工程指示 / 要求簡箋(E.I.)

工程指示編號：EI / 3187 / 21 修改版次：-
 工程編號：J - 852 工程名稱：亞皆老街中電
 工程項目：佛沙窗 師父板 (4th)
 收件人：生統 / 王良 發件人：Ant Yeung 日期：22/03/2021

To : Gammon Engineering & Construction Co., Ltd Ref no : 1980045.1-SM-50003-00
Attn : Mr. Dick Yuen / Mr. Jackson Mok Date : 9 September 2020
From : Ms. Cosimo Wong / Mr. Neo Wong Required Reply Date: 14 days
Project : Proposed Residential Development at 139 – 147 Argyle Street, Kowloon
Subject : Façade Works – Site Inspection Report #6

Site Inspection Report # 06

Photo #13

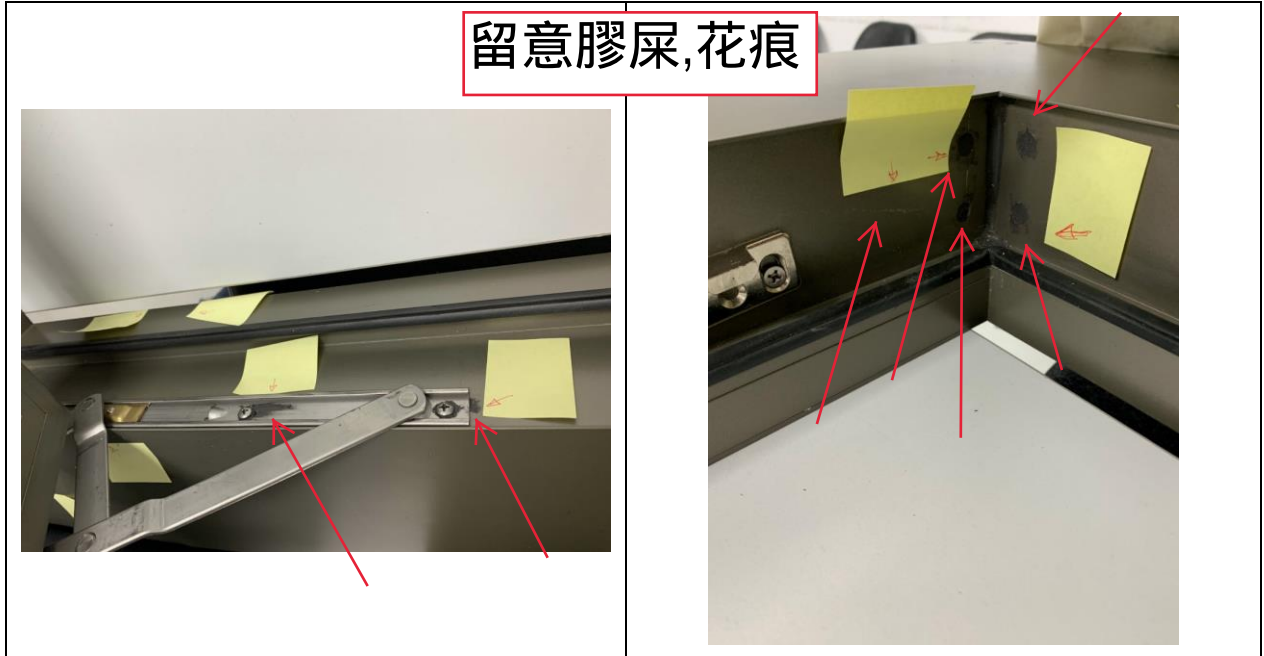
<p>Observation (Alum Window)</p>	<p>In general, no rectification works could be observed to address the observations/comments given by MFT during 1st joint inspection on 7th Aug 2020 (Details refer to report ref. no.: 1980045.1MFHK-SI-PRT-003-00, Photo #14 – Photo #36).</p>
<p>Recommendation</p>	<p>Midi is requested to address the observations/comments mentioned in the above inspection report case by case.</p>

Photo #14

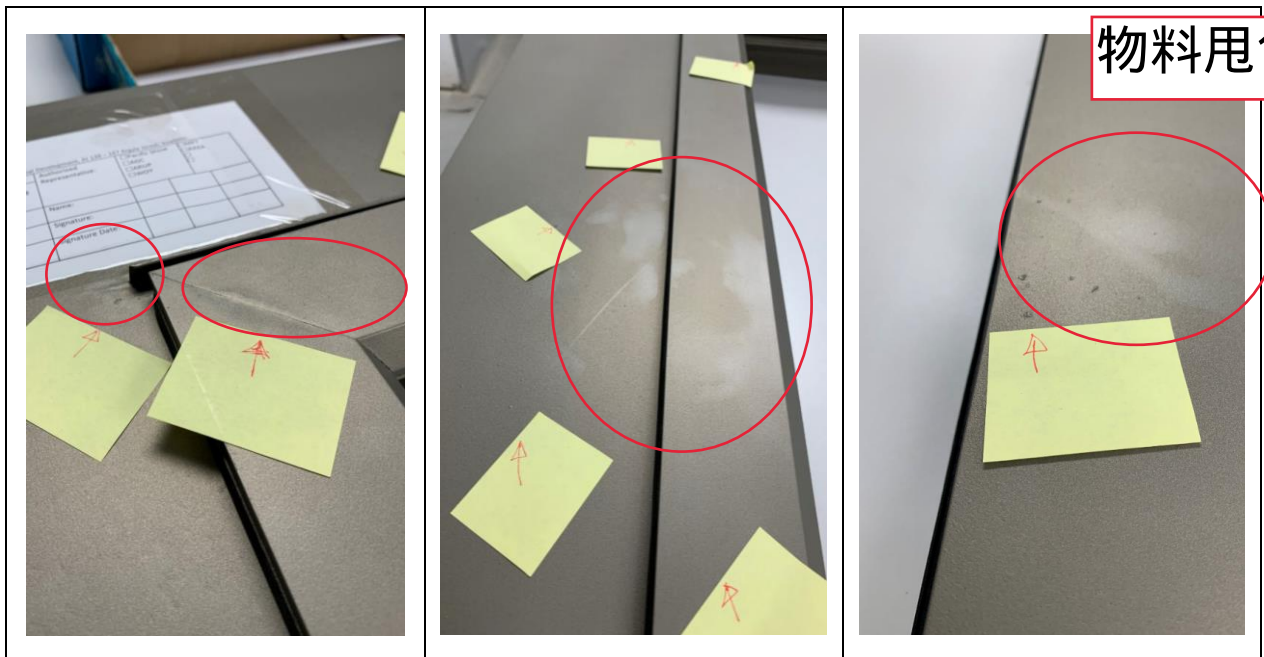
<p>Observation (Alum Window)</p>	<p>Further to Photo #13, noticeable touch-up works were also observed for the whole window sample especially at the locations with mitre joints.</p>
<p>Recommendation</p>	<p>Workmanship for touch-up works should be improved. Midi is required to rectify and resubmit the window sample immediately.</p>

Photo #33

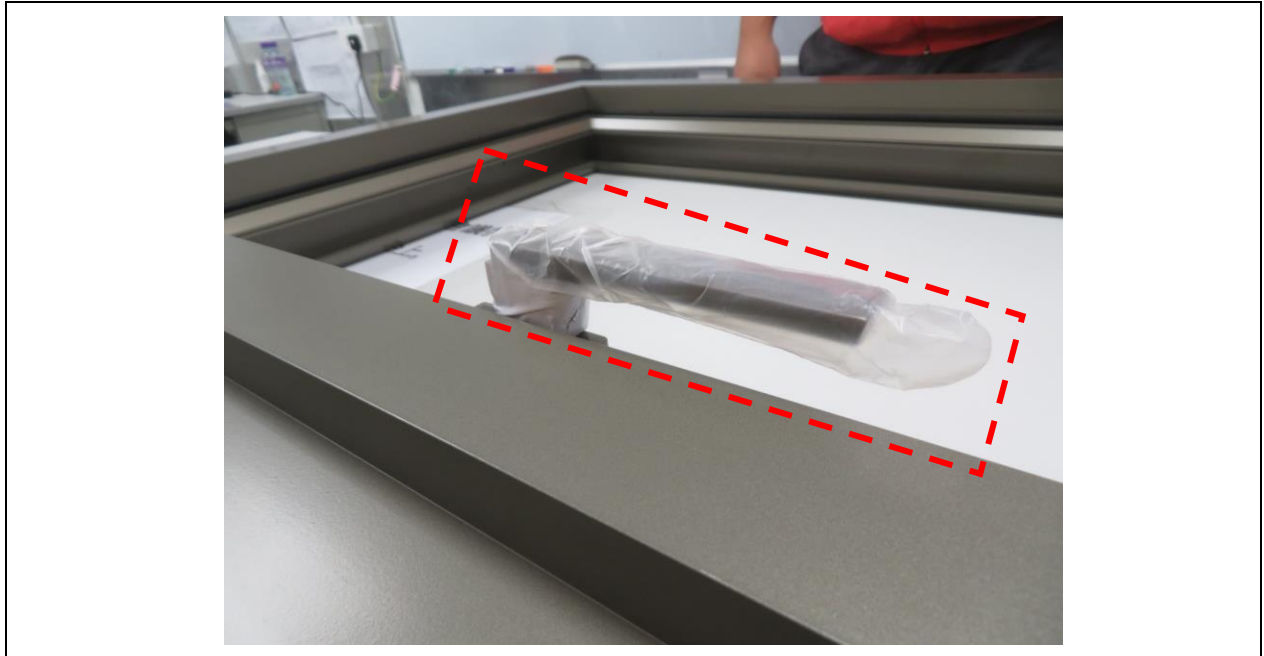
<p>Observation (Window Sash)</p>	<p>Noticeable gap between glazing bead covers of the sash were observed.</p>
<p>Recommendation</p>	<p>Improvement in quality of fabrication as well as assembly is recommended.</p>

Observation (Window Sash)	Sash handle.
Recommendation	Profile of sash handle to be further reviewed and confirmed by relevant parties.

Photo #34

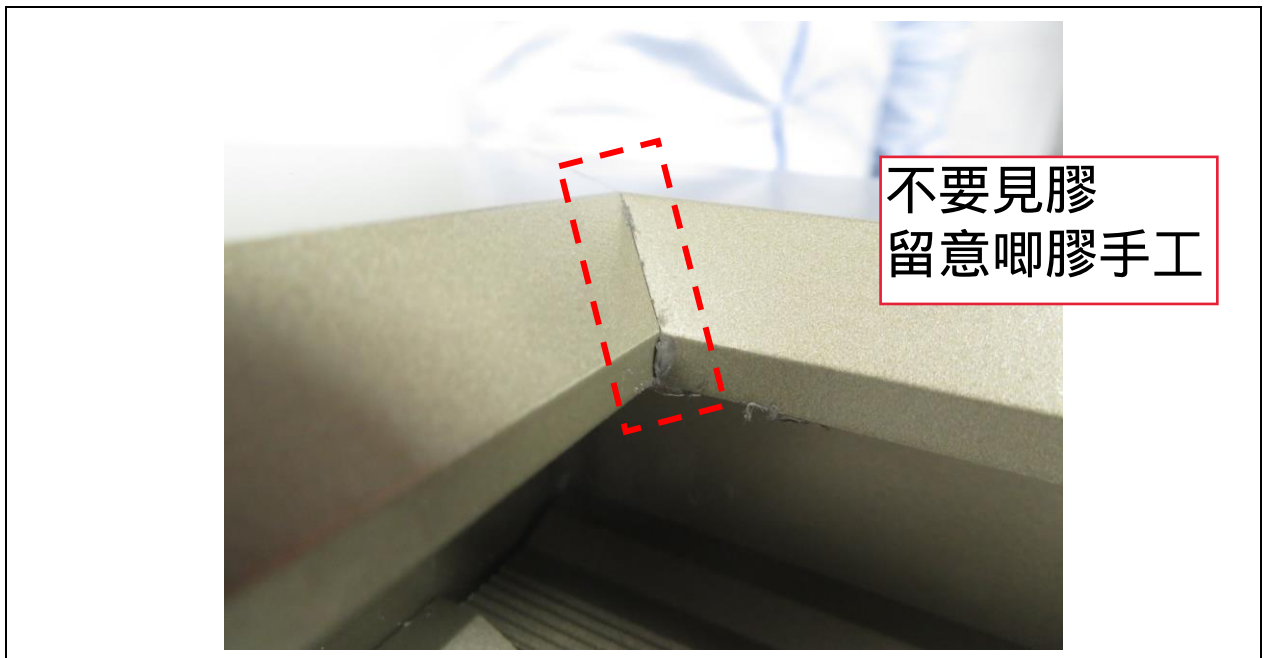
不要見膠
留意啲膠手工

Observation (Window Sash)	Excessive sealant was observed at the mitre joint of sash.
Recommendation	Improvement in the workmanship of applying sealant and cleaning in factory is needed.

Photo #35

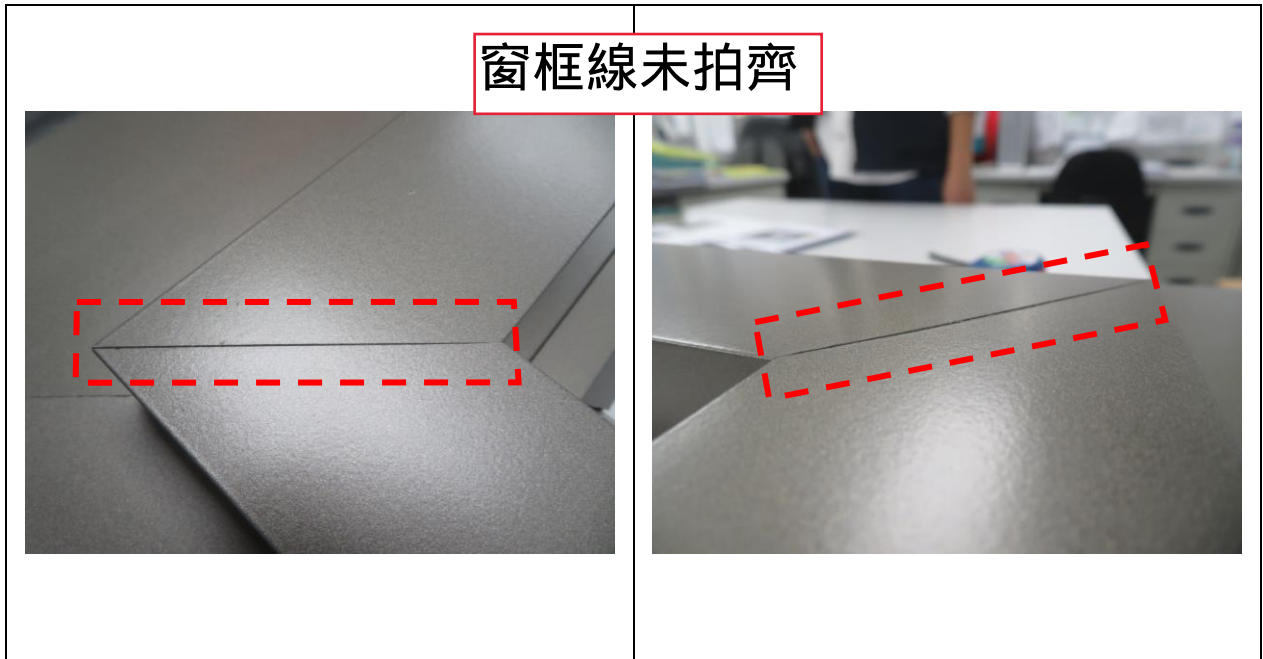
Observation (Window Sash)	A significant and uneven mitre joint for the sash.
Recommendation	Improvement in quality of fabrication as well as assembly is recommended.

Photo #36

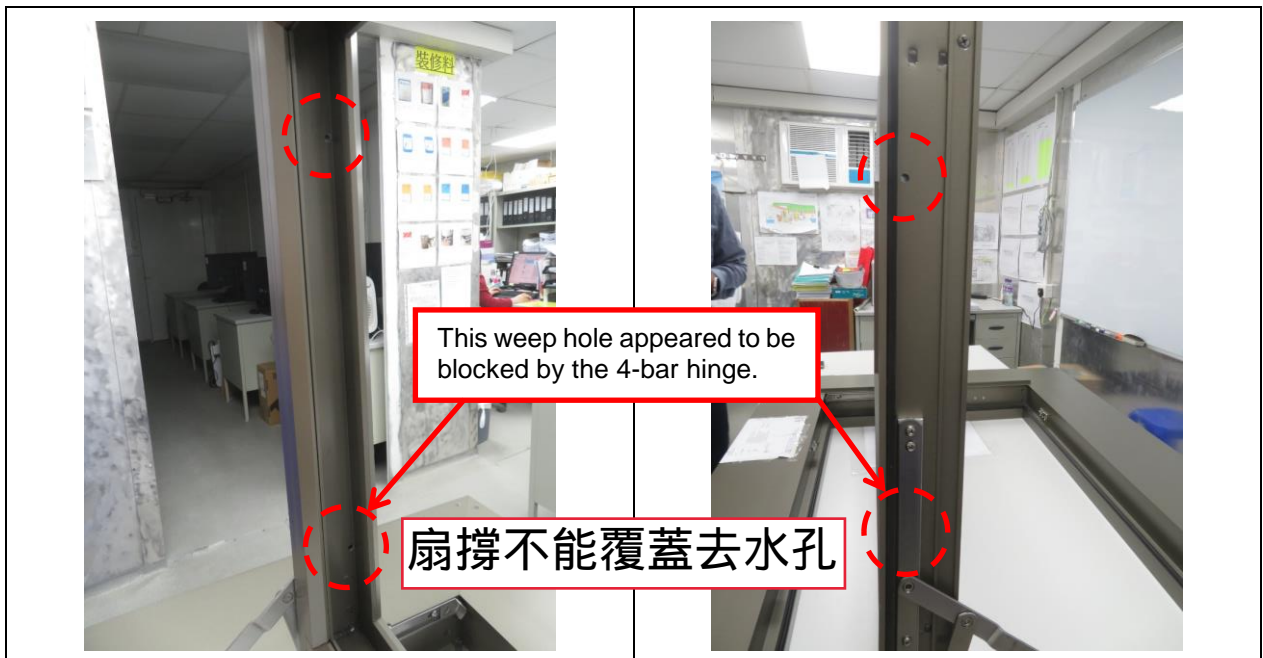
Observation (Window Sash)	Two weep holes were noted at the bottom of sash. One of the weep holes appeared to be blocked by the 4-bar hinge as indicated.
Recommendation	Review on the location of weep hole is recommended. It is also reminded that those weep holes should not be blocked by sealant.

Photo #37

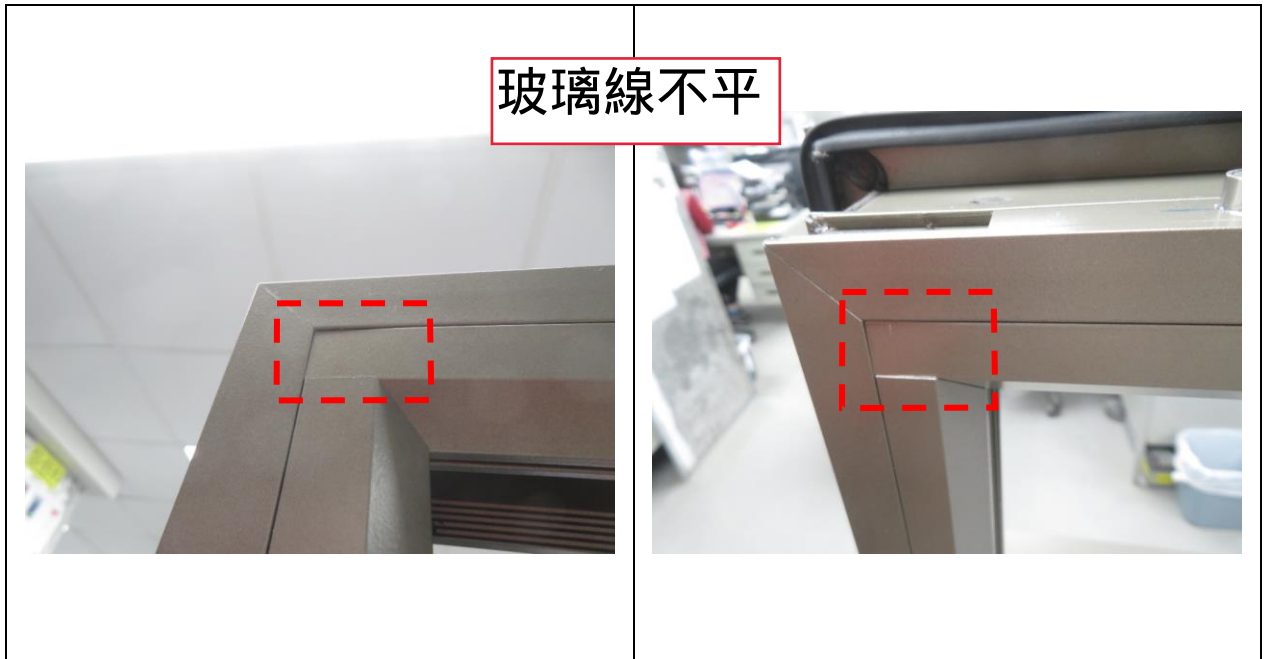
Observation (Window Sash)	Surfaces between glazing bead covers were not flush.
Recommendation	Rectification is required.

Observation (Window Sash)	Location of cut end of outer gasket around sash was noted.
Recommendation	Any aesthetic issue may defer to relevant parties' comments.

Photo #39

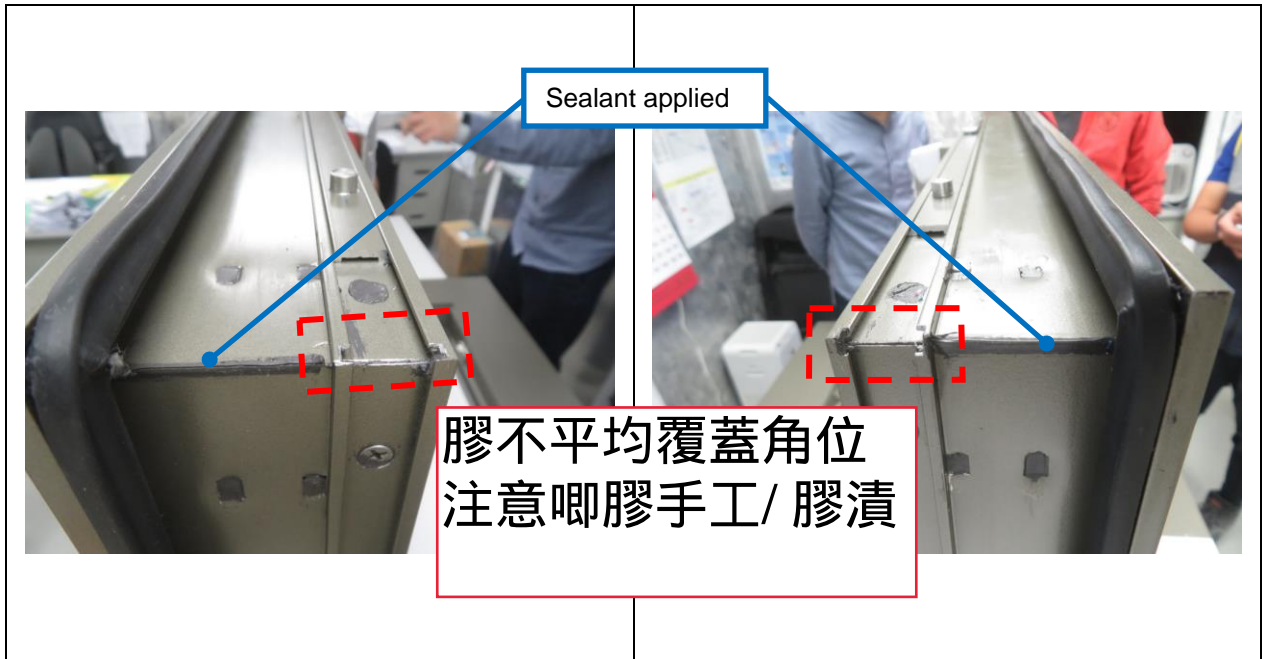
Observation (Window Sash)	Inconsistent sealant application was observed at the corners of sash.
Recommendation	Rectification is required. Sealant application at corners of sash should be standardized.

Photo #40

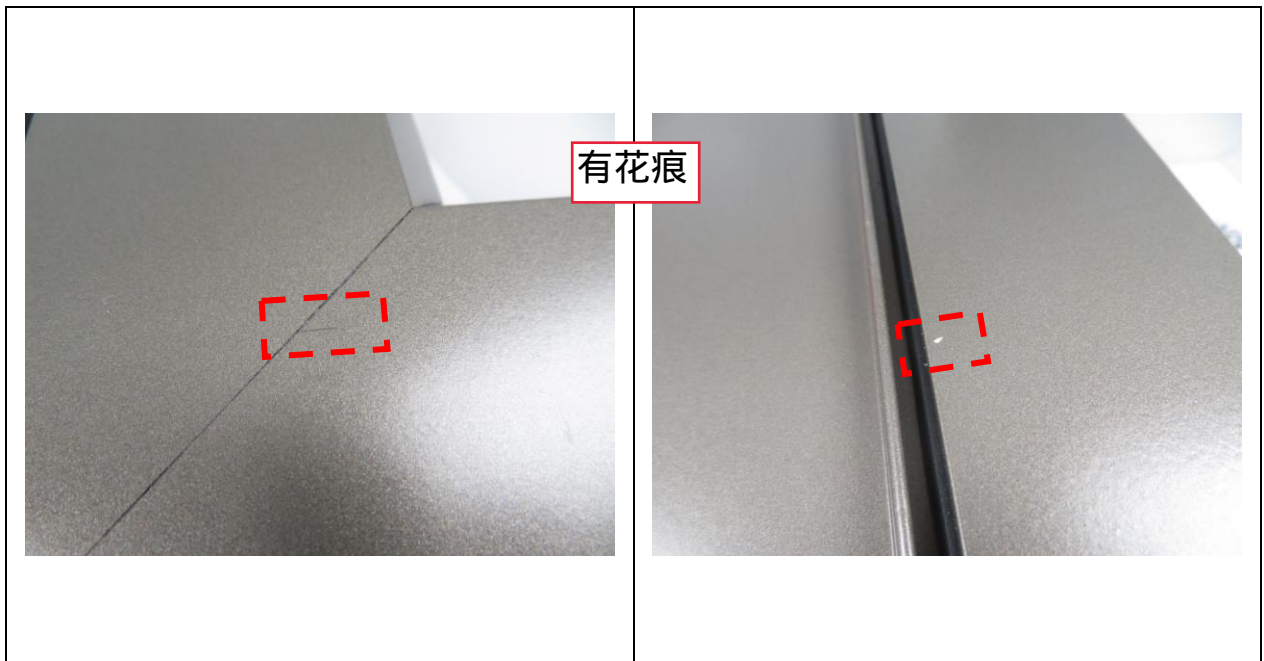
Observation (Window Sash)	Minor scratch and damage were noted on the coated surface of sash.
Recommendation	Review of protection and handling of material is required.

Photo #41

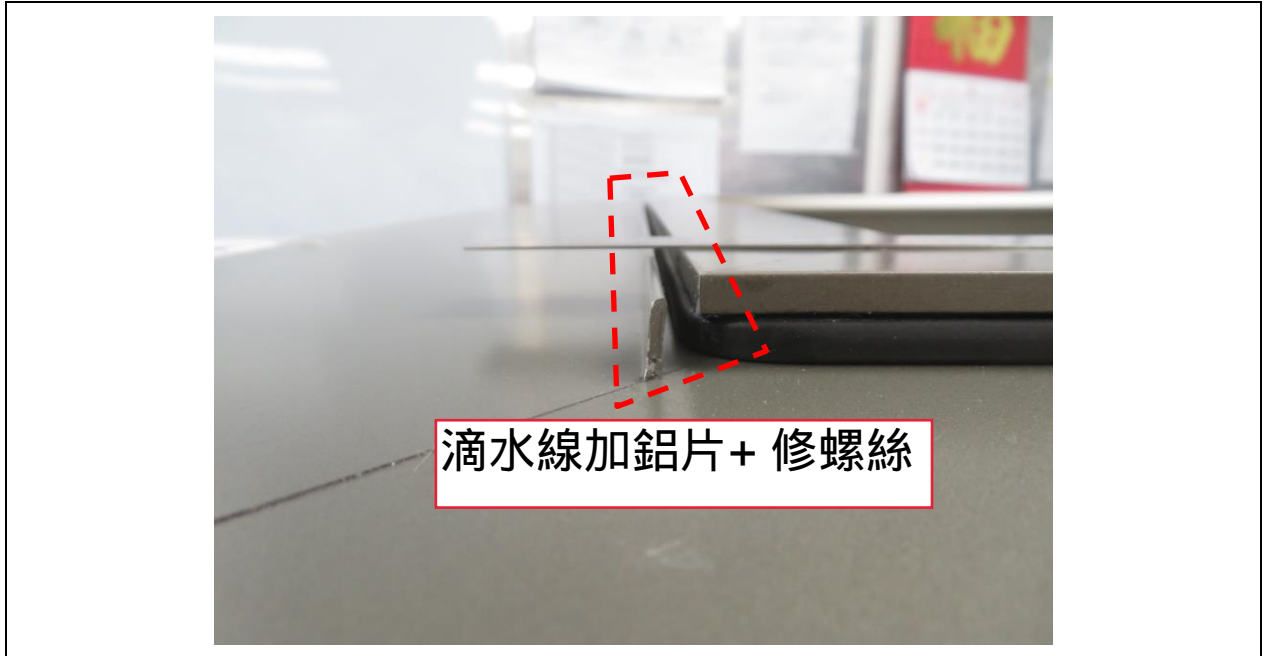
Observation (Window Frame)	Water drip should be projected out from the front surface of sash as per design in shop drawing.
Recommendation	Midi is required to clarify whether further in-out adjustment of sash at its locked position is still a possible way to tackle this quality issue.

Photo #42

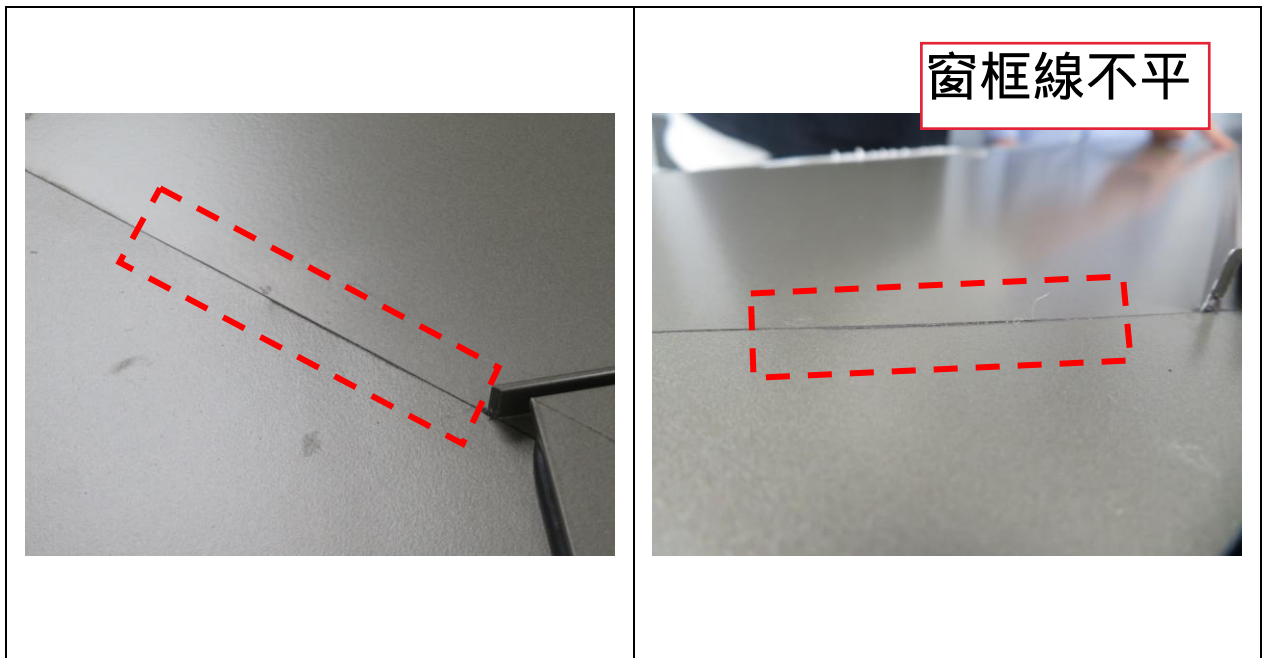
Observation (Window Frame)	A mitre joint for window frame was not flush.
Recommendation	Improvement in quality of fabrication as well as assembly is recommended.

Photo #43

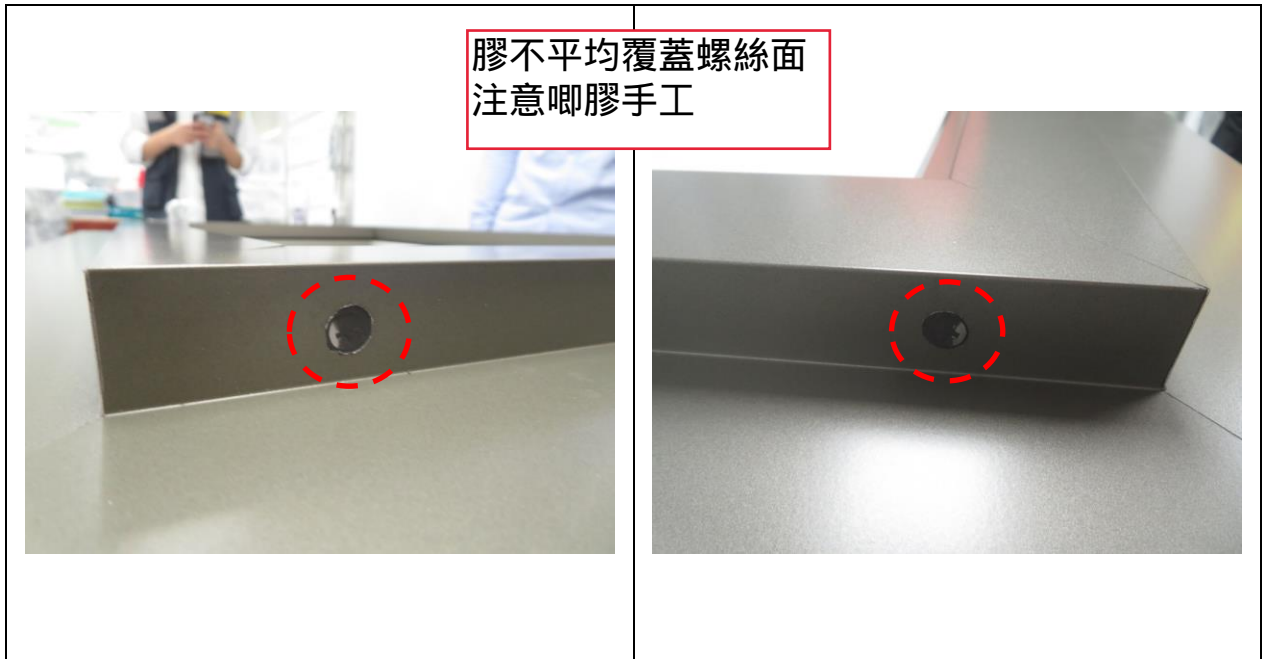
Observation (Window Frame)	Screw heads were partially covered by sealant.
Recommendation	Workmanship of sealant work should be improved.

Observation (Window Frame)	1) Inconsistent sealant application on fixing screws (i.e. screw heads partially/fully covered by sealant) at the corner of window frame. 2) Excess sealant was observed on a fixing screw of 4-bar hinge.
Recommendation	Workmanship of sealant work should be improved.
